# VICTORIA CROSS

OVER STATION DEVELOPMENT  
NORTH SYDNEY

DETAILED STATE SIGNIFICANT DEVELOPMENT APPLICATION

RESPONSE TO SUBMISSIONS

## VIEW ANALYSIS ALEXANDER APARTMENTS

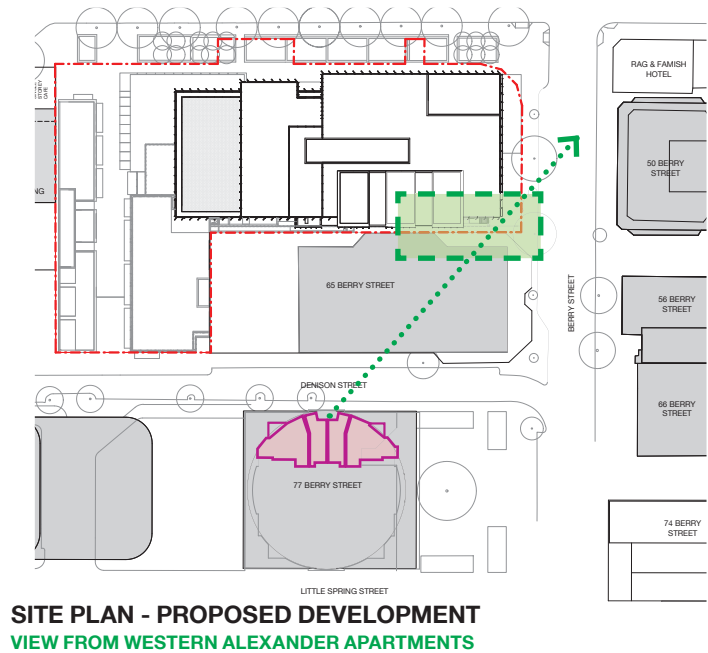
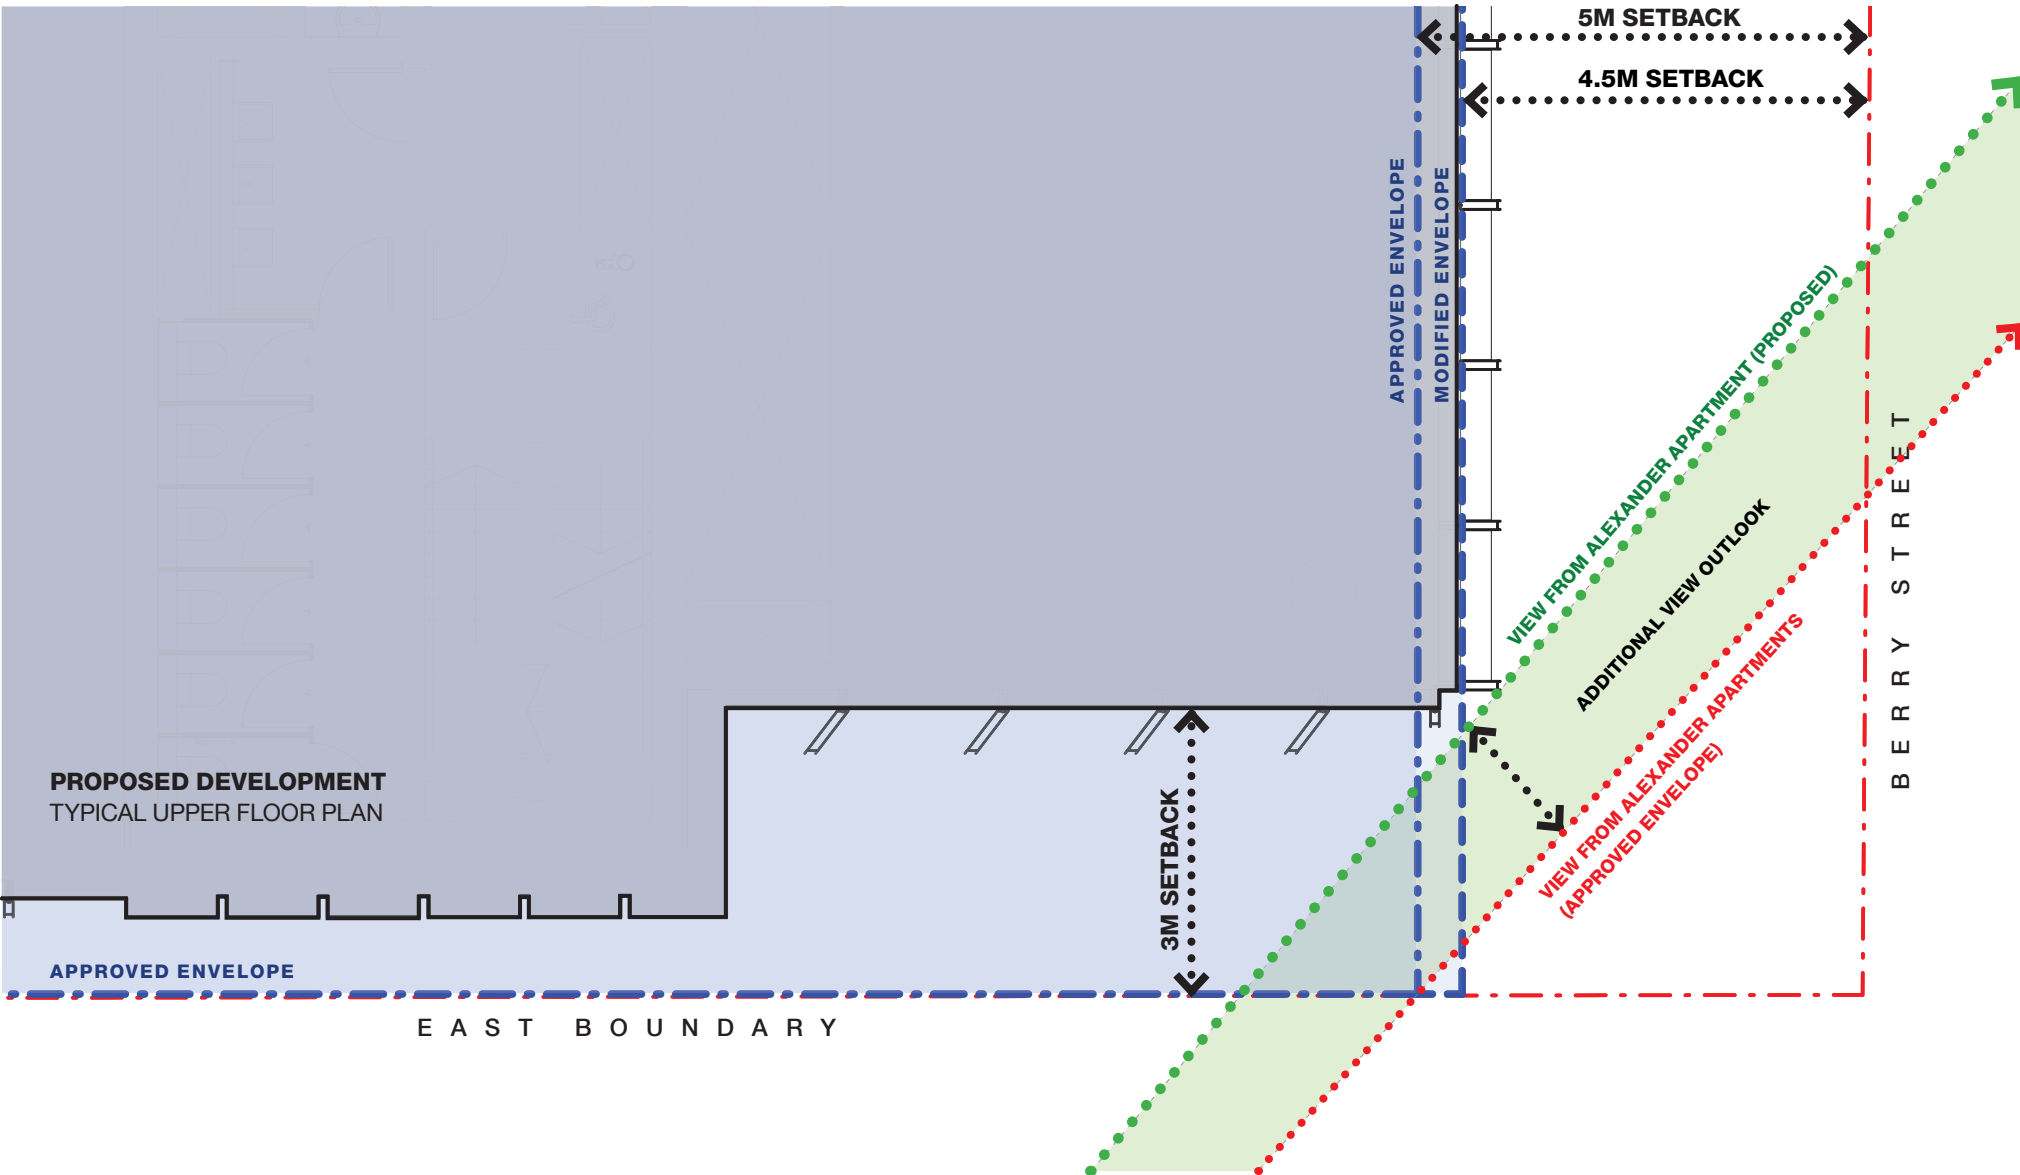
/ THE PROPOSED MODIFICATIONS TO THE BUILDING ENVELOPE AND DISTRIBUTION  
OF MASSING IN RELATION TO THE VIEW LOSS AND AMENITY CONCERNS RAISED IN PUBLIC SUBMISSIONS - DPIE

This page shows the increase in view outlook to the north west achieved from the balcony of west facing apartment #1 of Alexander Apartments.

## VIEW ANALYSIS ALEXANDER APARTMENTS

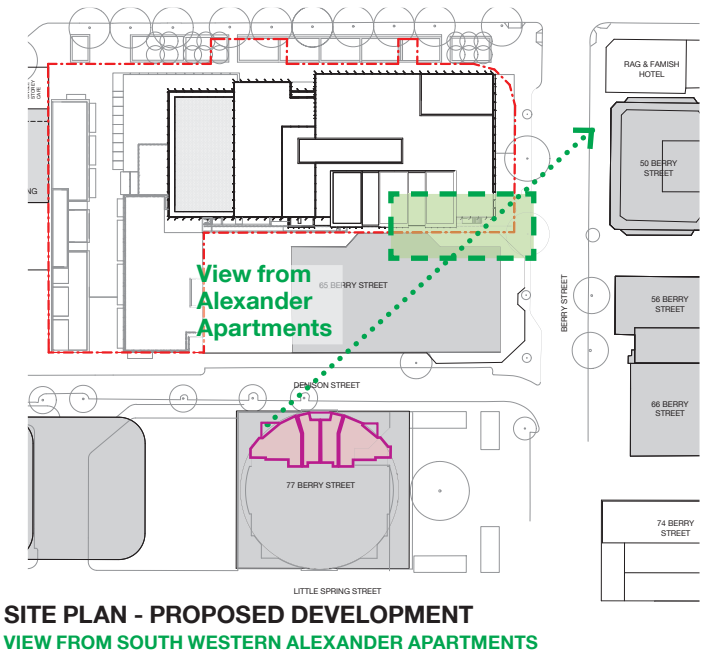
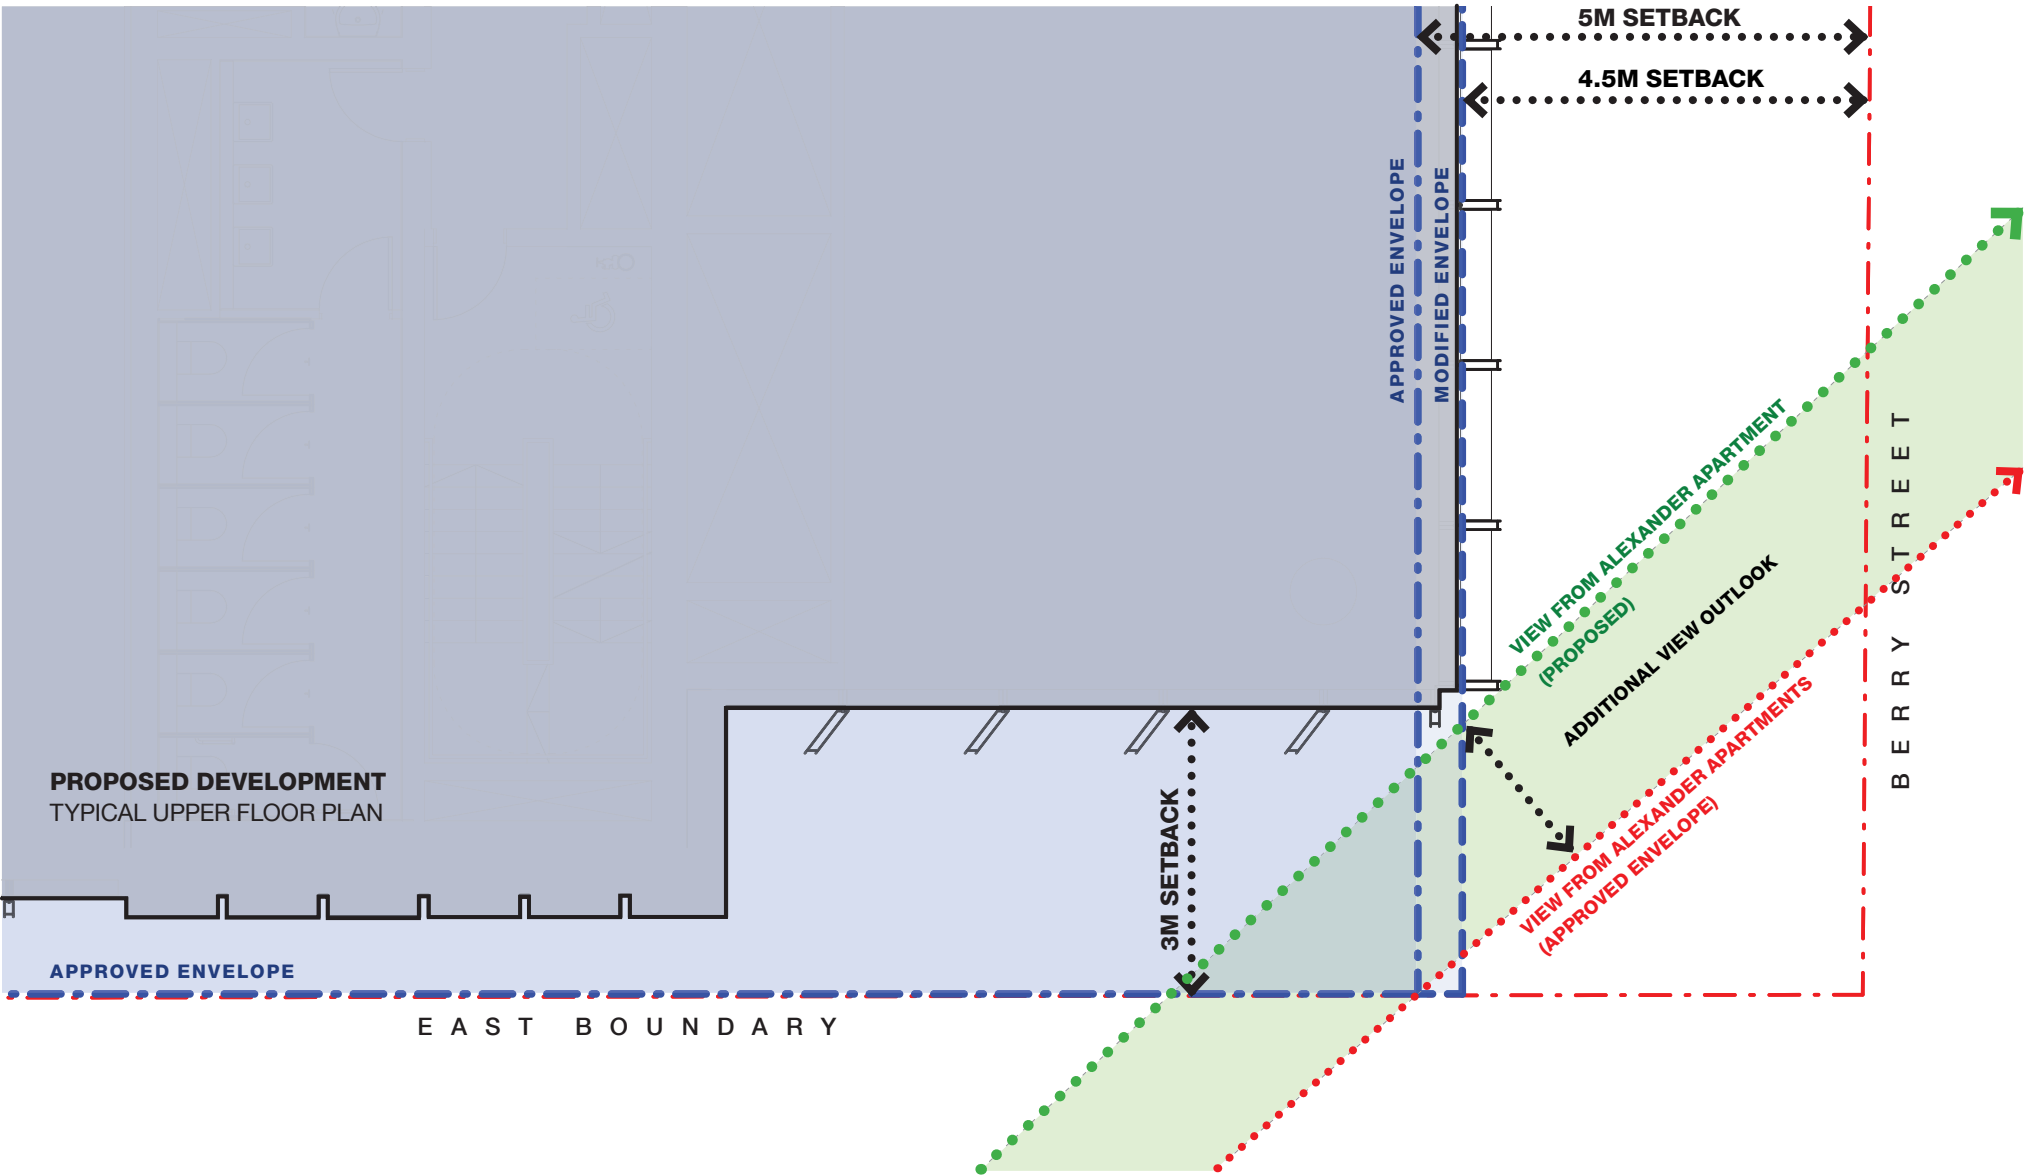
/ THE PROPOSED MODIFICATIONS TO THE BUILDING ENVELOPE AND DISTRIBUTION  
OF MASSING IN RELATION TO THE VIEW LOSS AND AMENITY CONCERNS RAISED IN PUBLIC SUBMISSIONS - DPIE

This page shows the increase in view outlook to the north west achieved from the balcony of west facing apartment #2 of Alexander Apartments.

In conclusion, views towards the north west from all west and north-west facing apartments in Alexander Apartments are improved under the proposed SSDA development than that permissible under the approved envelope.

# BUILT FORM AND SETBACKS VIEW ANALYSIS THE MILLER

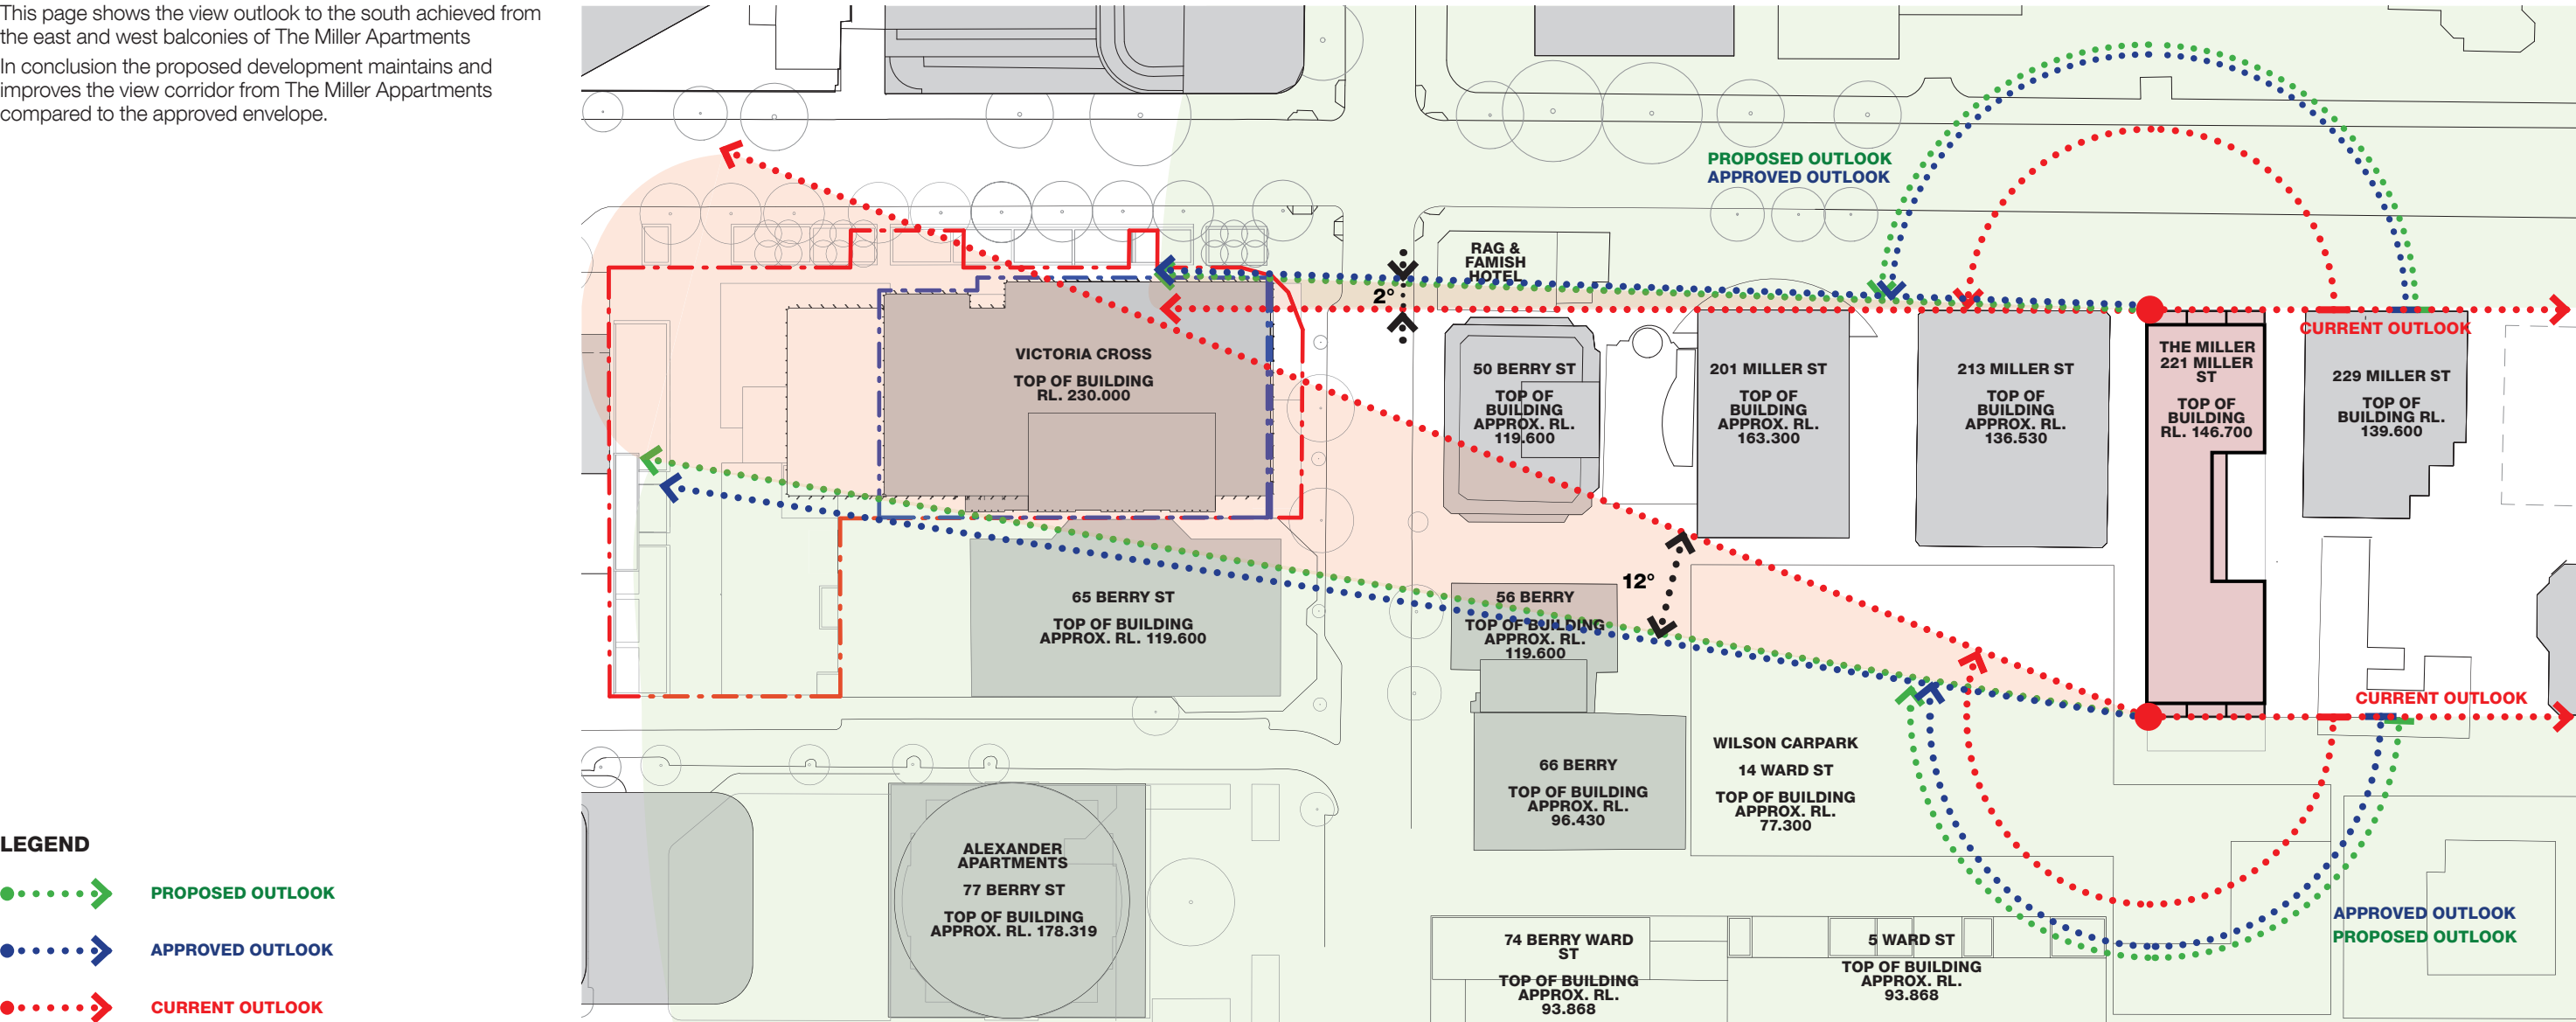
/ MAJOR VIEW LOSSES TO ALL NEW APARTMENTS WITHIN 221 MILLER STREET  
“THE MILLER” HAS NOT BEEN CONSIDERED AND NEEDS TO BE INDIVIDUALLY ADDRESSED. - ‘PUBLIC’

This page shows the view outlook to the south achieved from the east and west balconies of The Miller Apartments  
In conclusion the proposed development maintains and improves the view corridor from The Miller Apartments compared to the approved envelope.
